## XR150/XR550 Series Control Panels

March 2017

### Hardware Update

Figure 1: XR Panel with Cell Pin Header Shroud

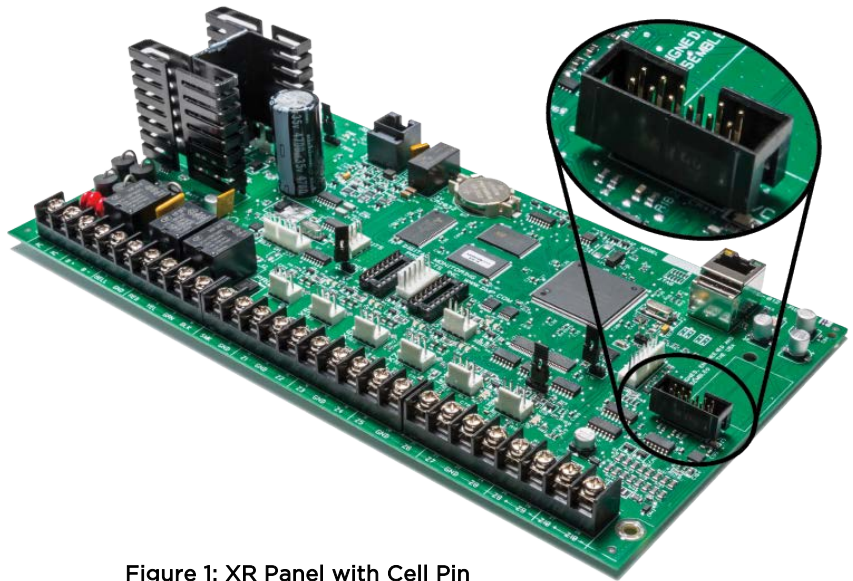
XR150/XR550 Series panels now have a built-on plastic shroud around the cell pin header. This plastic shroud prevents the pins from horizontally misaligning when a cellular communicator is installed. Misaligning cell pins can cause damage to both the panel and to the cellular communicator.
